# Access Compliance Report

## Public Rights-of-Way

Intersection ID: 5591	Main Street: CARVER_BV	Cross Street: HAWKINS_PL	Location: N
ADA ID: F545D303C83E	Ramp Type: Para	Initial Pass/Fail: Fail	Overall Compliance: No
			Severity Score: 31.25

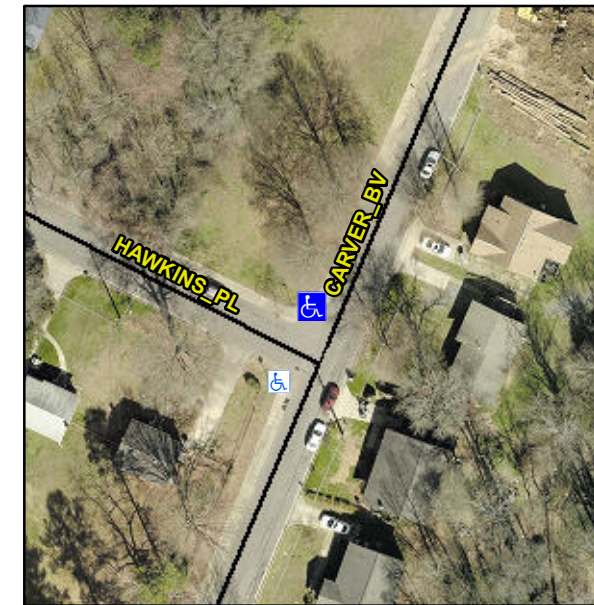
**RT RP < 5%**

**R304.5.1, R304.3.2, R304.5.3**

**Remove & Replace Entire Ramp.**
